AMENDMENT OF SOLICITATION/MODIFICATION OF CONTRACT			1. CONTRACT ID CODE		PAGE OF PAGES 1 4		
2. MODIFICATION NO.: 0004		3. EFFECTIVE DATE APR 02, 2003		4. REQUISITION/PURCHASE REQ. NO. W81W3G-2035-7181		PROJECT NO. (If applicable)	
6. ISSUED BY Department of the Army Baltimore District, Corps of Engineers Contracting Division P.O. Box 1715 Baltimore MD 21203-1715		CODE CA31		7. ADMINISTERED BY: Contracting Division, Contracts Branch CENAB-CT-C 10 S. Howard ST. Room 7000 Baltimore, MD 21203-1715		CODE E1P0100	
8. NAME AND ADDRESS OF CONTRACTOR (No., street, county, State and ZIP Code)				(x)		9A. AMENDMENT OF SOLICITATION NO. DACW31-03-R-0003	
				X		9B. DATED (SEE ITEM 11) JAN 13, 2003	
						10A. MODIFICATION OF CONTRACT/ ORDER NO.	
						10B. DATED (SEE ITEM 13)	
CODE		FACILITY CODE

**STADIUM IMPROVEMENTS
ANACOSTIA SENIOR HIGH SCHOOL, WASHINGTON, DC**

AMENDMENT NO. 0004 TO ADVERTISED RFP DACW31-03-R-0003
EFFECTIVE APR 02, 2003

SK - A
1

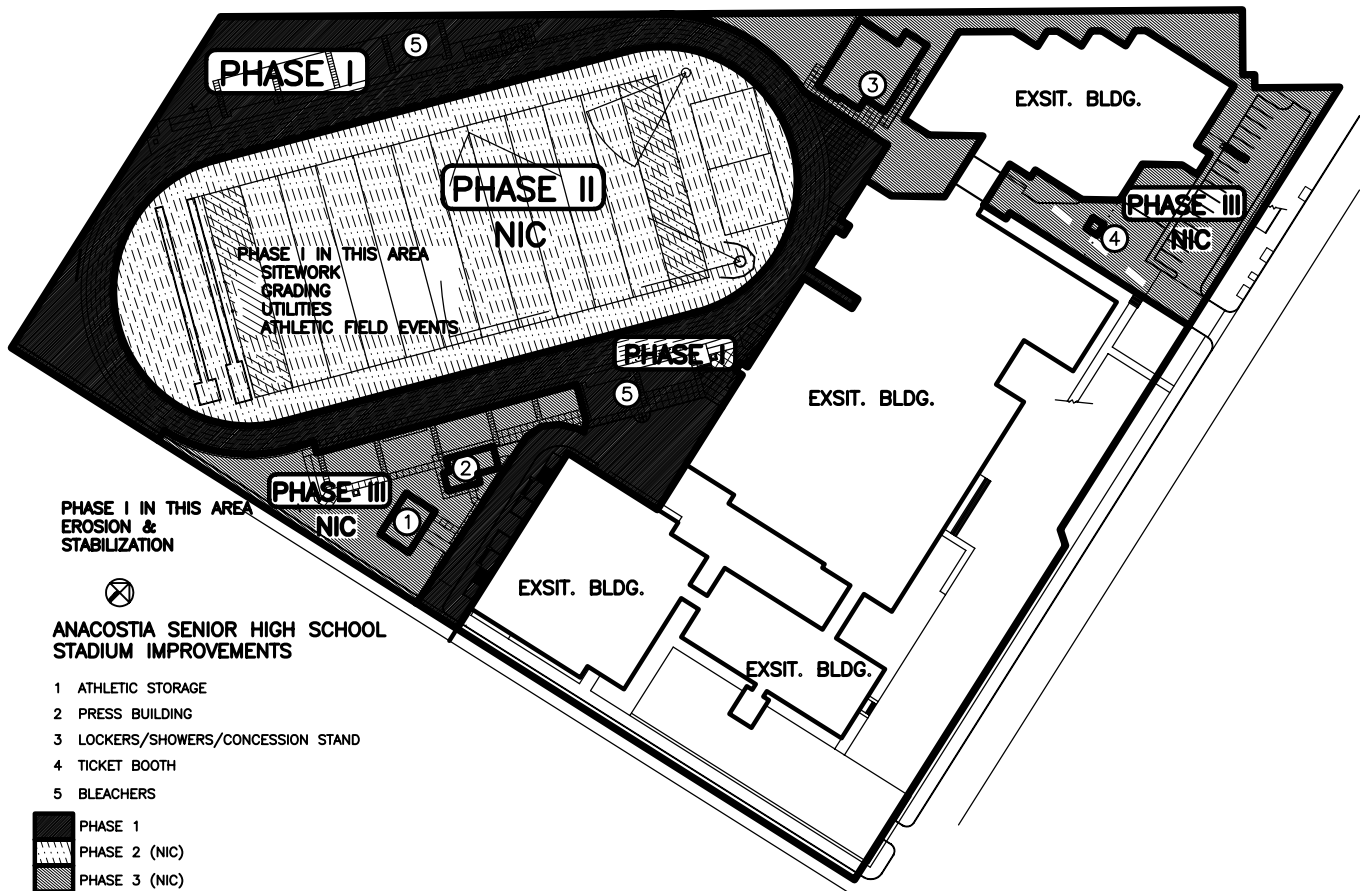
d) Phasing on attached Sketch SK-A1 , dated March 25, 2003, supercedes that shown on Sheet A-01 plan.

1 RETAINING WALL DET. S9 S9 SCALE: N.T.S

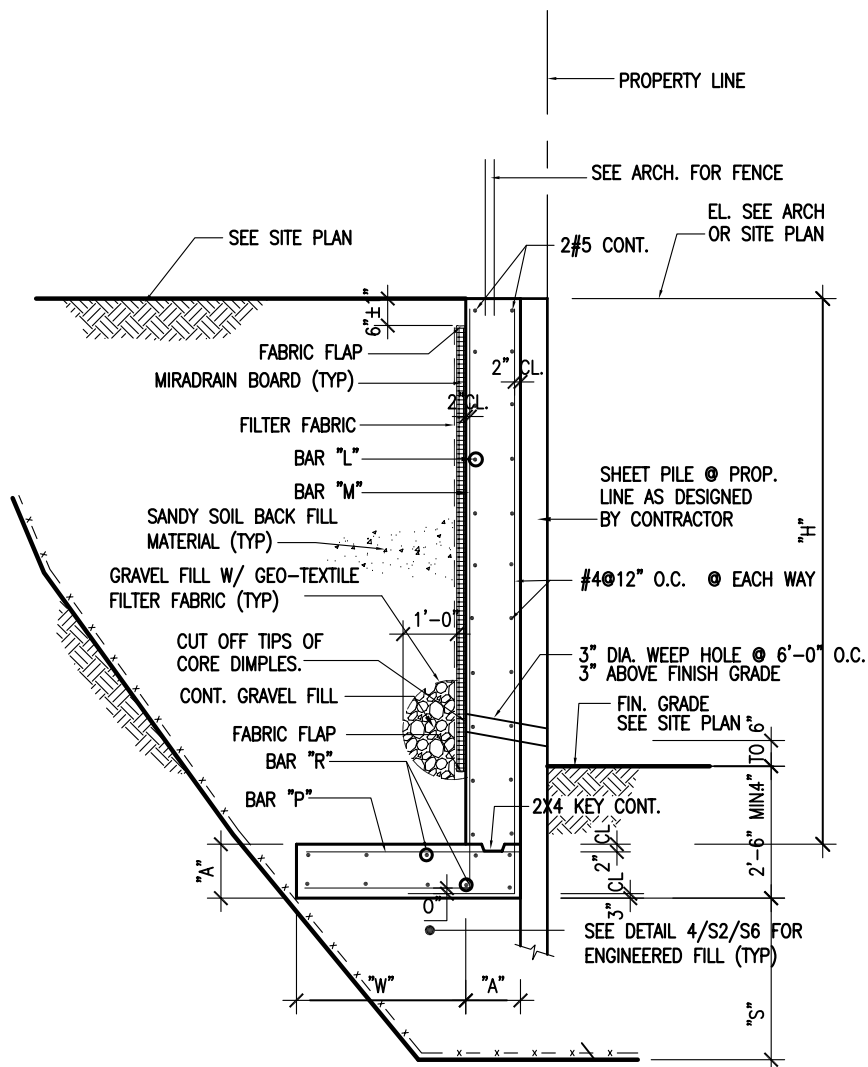
a) Revise Detail 1/S9 in accordance with the attached Sketch SK-S-1, dated March 25, 2003.

1. SUBDRAIN FILTER FABRIC SHALL BE CONTINUOUS.
2. PROVIDE TENSION LAP SPLICE CLASS "B" FOR ALL VERTICAL BARS IF REQUIRES LAP SPLICE.
3. 4" DIA PERFORATED PIPE SHALL BE CONTINUOUS AND CONNECT STORM SEWER OR DAY LIGHT SPILL. COORDINATE WITH SITE PLAN
